Am186™CC/CH/CU

Microcontrollers User's Manual

This document amends the *Am186™CC/CH/CU Microcontrollers User's Manual*, order #21914B. It consists of these parts:

Figure 13-9   Autobaud Enhancement

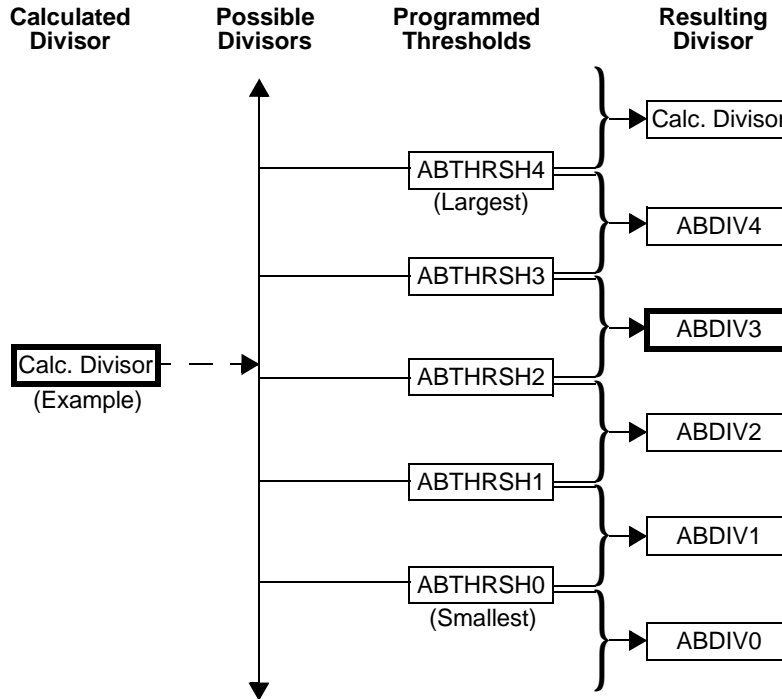
13-18	Figure 13-9 Autobaud Enhancement	[Existing figure]	[Replace with Figure 13-9 on page 10 of this amendment.]	Update and clarify figure.
13-19	Table 13-5 UARTs Interrupt Sources	[Existing table]	[Add new row before "Overrun error on receive FIFO":] Break on receive FIFO, RSIE (Off), BRKIM (Off)	Add BRKIM bit.
13-20	**13.5.7 Break Detection and Generation**, first paragraph	[Existing first paragraph.]	[Add new sentence and note:] If the receive FIFO is enabled (High-Speed UART only), the break immediate (BRKIM) status bit indicates the break condition as soon as it occurs; the FER and BRK status bits are not set until the corresponding character is loaded into the HSPRXD register. ***Note:*** *The BRKIM bit is not available in parts released prior to revision C1. For processor revision information, see the PRL register description in the* Am186CC/CH/CU Register Set Manual*, order #21916B [and its amendment, order #21916B/1].*	Add BRKIM bit.

Replace Figure 13-9 on page 13-18 of the manual with the following figure.

1. *If the calculated divisor is larger than the largest ABTHRSHx bit field value, the resulting divisor is the same as the calculated divisor.*

2. *The ABTHRSH4 or ABTHRSH3 bit field must contain the largest threshold value. If the ABTHRSH4 bit field is not the largest threshold, it must be 0. The remaining ABTHRSHx bit fields must be programmed with successively smaller thresholds for lower-numbered ABTHRSHx bit fields. If all five thresholds are not needed, the lowest-numbered ABTHRSHx bit fields (ABTHRSH0, ABTHRSH1, etc.) can be cleared or left in their default disabled state (00h).*

Figure 17-3   GCI Terminal Mode Frame Structure

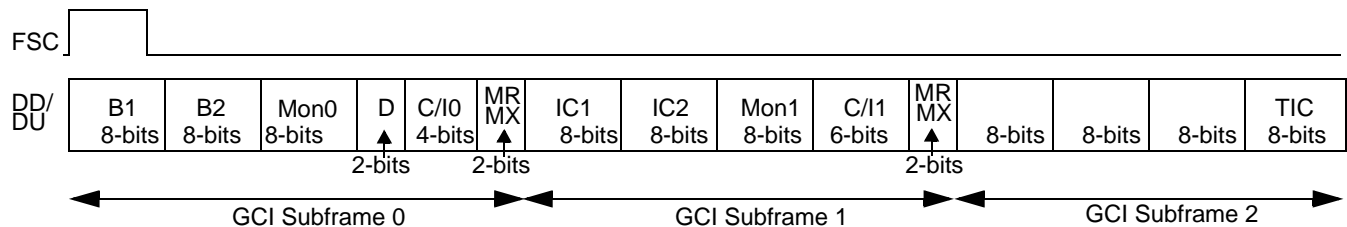
Change Figure 17-3 on page 17-8 to the following. The new figure changes the FSC waveform.

Figure 18-2   USB With Internal Transceiver

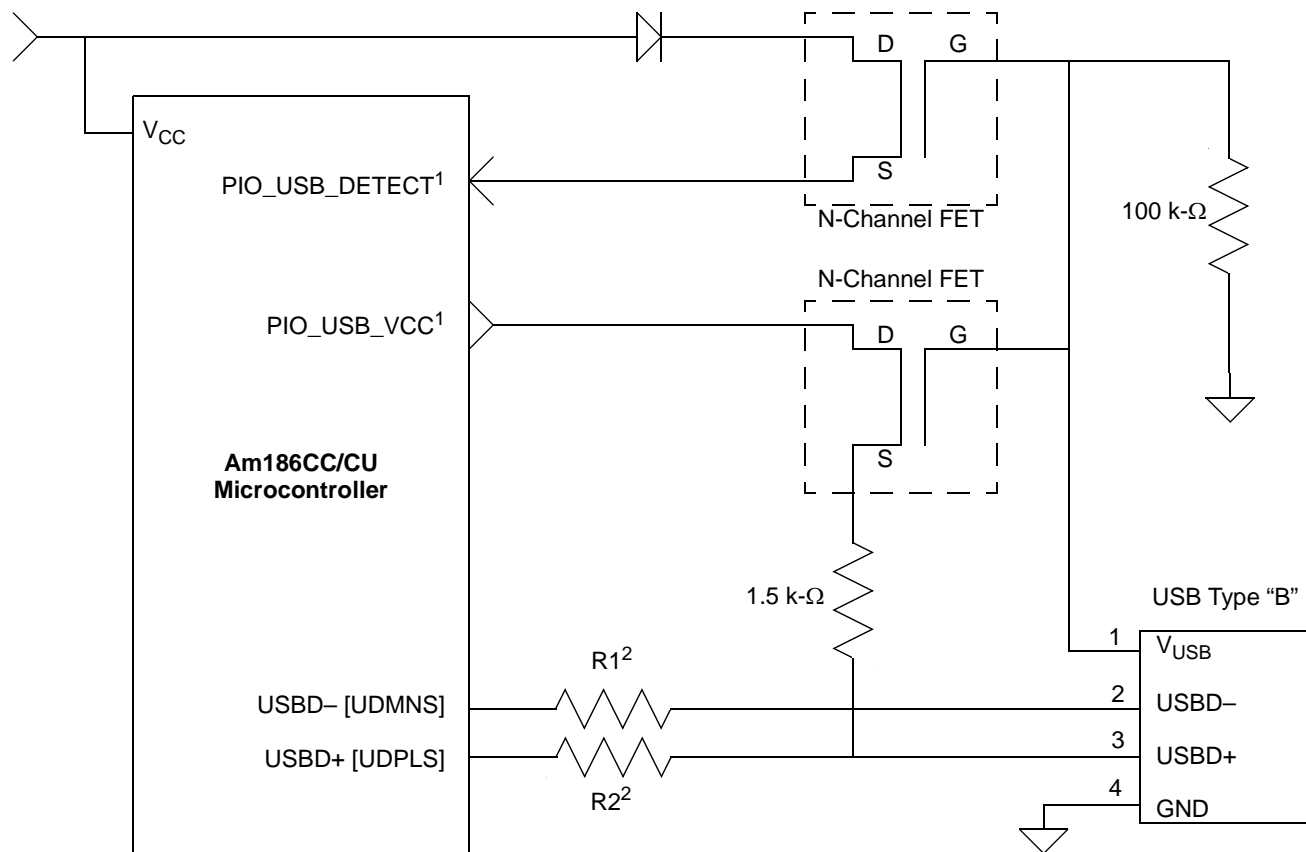
Figure 18-2 USB With Internal Transceiver	[Existing figure]	[Change to new figure 18-2, shown on page 11 of this amendment.]	Add pulldown to V_{USB}. Clarify PIO use in example.
18-5	**Figure 18-3 USB With External Transceiver**	[Existing figure]	[Change to new figure 18-3, shown on page 12 of this amendment.]	Add pulldown to V_{USB}.
18-30	**18.5.12 Endpoint Definitions**, second paragraph	The USB Specification, Version 1.0 defines the endpoint configuration process:	The USB Specification, Version 1.0 defines the endpoint configuration process.	Change colon at end of sentence to a period.

Change Figure 18-2 on page 18-4 to the following. The new figure adds a 100 k-Ω pulldown resistor to V_{USB} and a note to clarify PIO use in the example.

1. *For the PIO_USB_DETECT and PIO_USB_VCC signals, select PIO pins that default to input operation. If a PIO with an internal pullup resistor is used, add a 10 k-Ω external pulldown resister to override the internal 50 k-Ω pullup. See Table 9-1 on page 9-3 [of the manual] for PIO signal defaults.*

2. *The USB specification requires a driver impedance between 29 Ω and 44 Ω on the USBD+ and USBD– signals. For information about driver characteristics and selecting a series resistor value, see the data sheets for the Am186CC and Am186CU microcontrollers.*

Figure 18-3   USB With External Transceiver

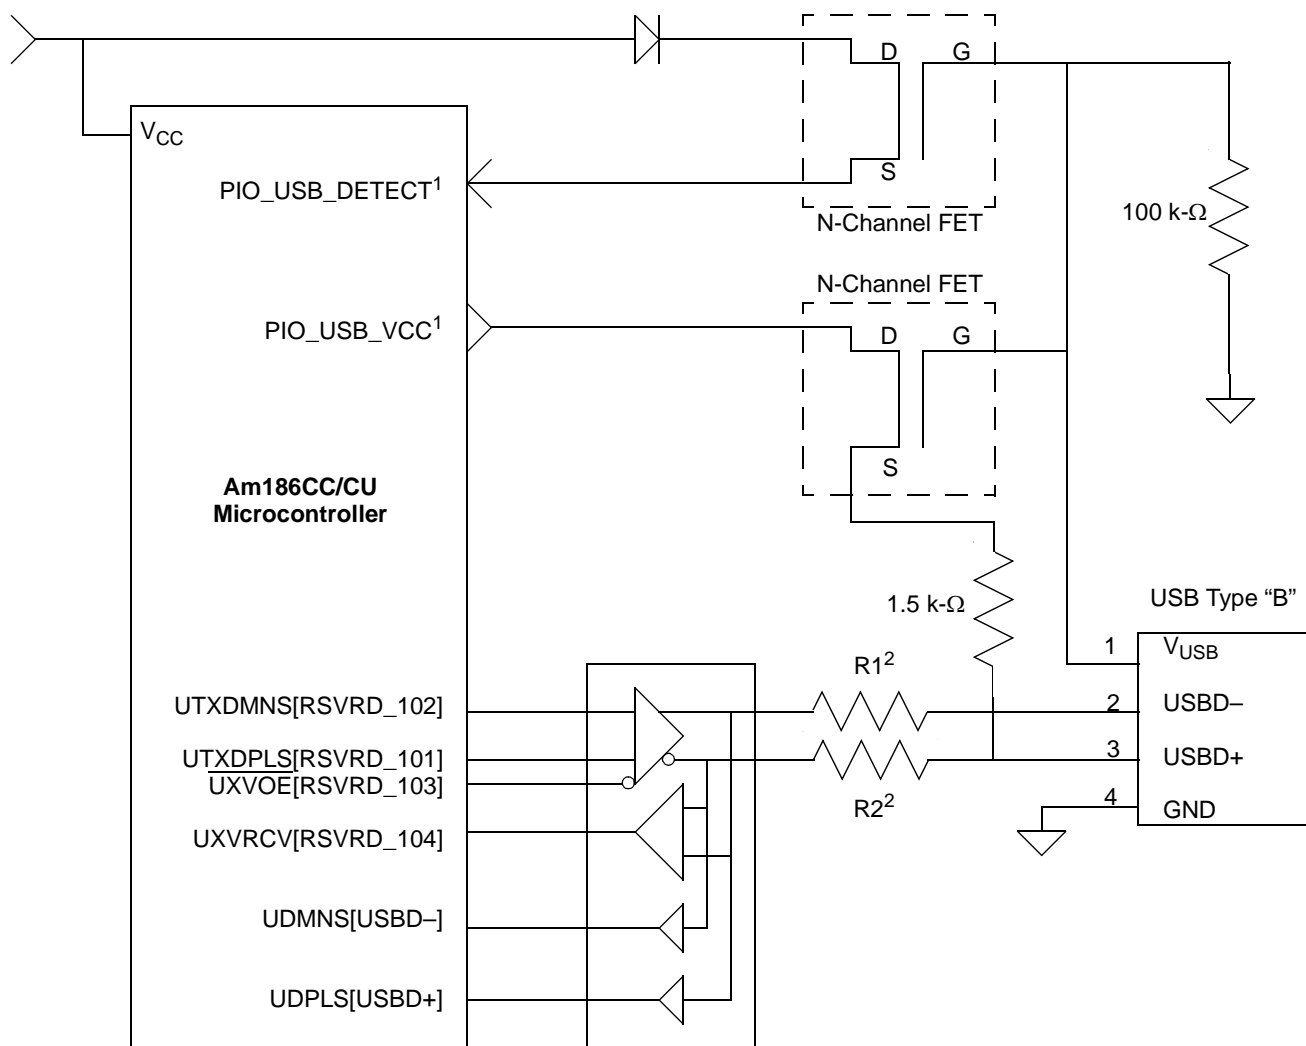
Change Figure 18-3 on page 18-5 to the following. The new figure adds a 100 k-Ω pulldown resistor to V_{USB} and a note to clarify PIO use in the example.

1. *For the PIO_USB_DETECT and PIO_USB_VCC signals, select PIO pins that default to input operation. If a PIO with an internal pullup resistor is used, add a 10 k-Ω external pulldown resister to override the internal 50 k-Ω pullup. See Table 9-1 on page 9-3 [of the manual] for PIO signal defaults.*

2. *The USB specification requires a driver impedance between 29 W and 44 W on the USBD+ and USBD– signals. For information about driver characteristics and selecting a series resistor value, see the documentation for the external transceiver.*
